Model type:
AVF109SEX

Commercial code:
F034043

1140150B Exploded views

Fig . 001

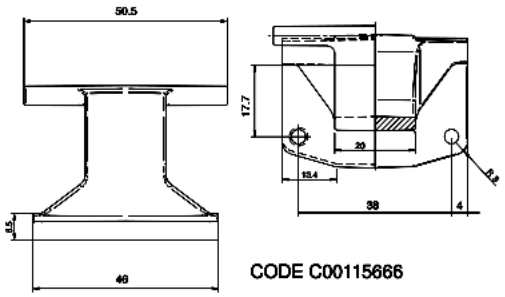
n1040349: Introduction of 150° Zamac hinge on Ariston 46 models.

From serial no. 50207.0001, all Ariston models produced in the Teverola factory (see table 001 attached) with industrial code (given on the rating plate) starting with 46, have been equipped with a Zamac hinge with 150° opening angle, code C00115666

(see Fig.001).
This modification has involved the introduction of the following items:

Code C00115670 - Complete door EVOII 150° white 27 with standard glass;
Code C00115674 - Complete door EVOII 150° white 27 with long glass;
Code C00115667 - EVOII body for 150° hinge white 27;

The premodified items are not interchangeable separately with the modified ones.

Code C00110133 - Complete door EVOII Standard 180° white 27 standard glass;
Code C00092157 - Complete door EVOII 180° white 27 long glass;
Code C00096193 - EVOII body for 150° hinge white 27;

The hinge code C00064541 continues to be used on the build-under models produced in the Comunanza factory.

Fig . 001

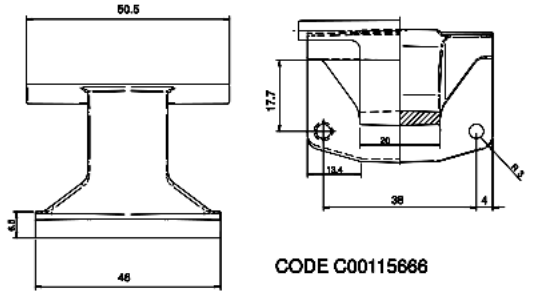
n1040353: Introduction of 150° Zamac hinge on Ariston models (Comunanza).

From serial no. 50207.0001, all Ariston models produced in the Comunanza factory (see table 001 attached) with industrial code (given on the rating plate) starting with 80, have been equipped with a Zamac hinge with 150° opening angle, code C00115666 (see Fig.001).
This modification has involved the introduction of the following items:

Code C00115670 - Complete door EVOII 150° white 27 with standard glass;
Code C00115674 - Complete door EVOII 150° white 27 with long glass;
Code C00115668 - Complete door EVOII 150° silver with standard glass;
Code C00115673 - Complete door EVOII 150° silver snella standard glass;
Code C00115662 - EVOII body for 150° hinge white 27
Code C00115663 - EVOII body for 150° hinge silver 27
Code C00115664 - Snella EVOII body for 150° hinge white 27
Code C00115665 - Snella EVOII body for 150° hinge silver

The premodified items are not interchangeable separately with the modified ones.

Code C00096416 - Complete door EVOII LB 180° standard depth silver;
Code C00097374 - Complete door EVOII 180° WD 180° white 27 long glass;
Code C00110133 - Complete door EVOII Standard 180° white 27
Code C00110178 - Complete door EVOII Snella 180° Silver;
Code C00091836 - EVOII body white 27 for 180° hinge;
Code C00094306 - EVOII body silver for 180° hinge;
Code C00094305 - Snella EVOII body white 27 for 180° hinge;
Code C00094307 - Snella EVOII body silver for 180° hinge;

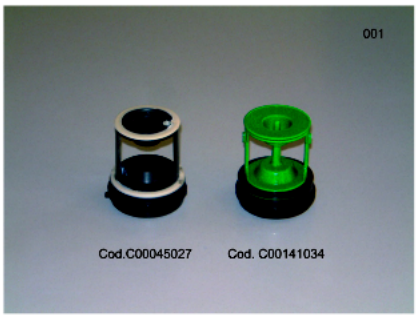
n1040378: 3.5 three phase module, factory 80 (Comunanza)

From October 2005, the new 3.5 module has been installed on three phase Comunanza models (80)

New parts:
C00254298 - Three phase module for card LB-WD 3.5;
C00141769 - J10-MV J16-EVA/NT WD cables (see picture attached).

Premodification parts:
C00257406 - MODULO WD>1200 G. +SC FW2.74 (CARD)
C00093717 - Cables J10-EWA MV NT WD.

The new items are not interchangeable with the premodification ones.

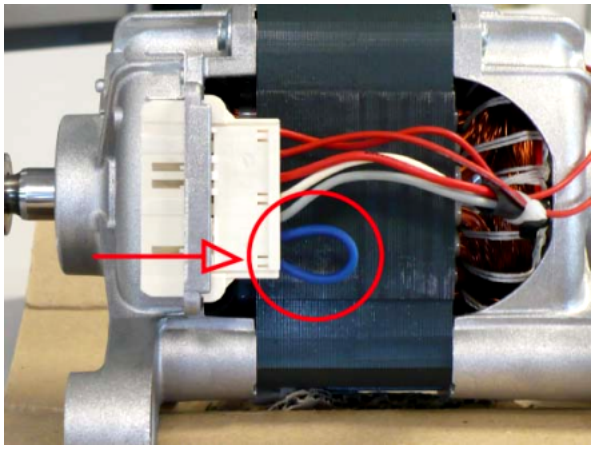
n4008f00: Thermic link wire removed on three-phase motor

Attention!
When you assist the premodification models using the new motor code you MUST use the thermic link wire code C00265838.

The spare part warehouses will manage the premodification motor until the end of the stock, after they will be replaced with new ones and thermic link wire.

In the attached image you can see the fixing of thermic link wire in the motor therminal box.
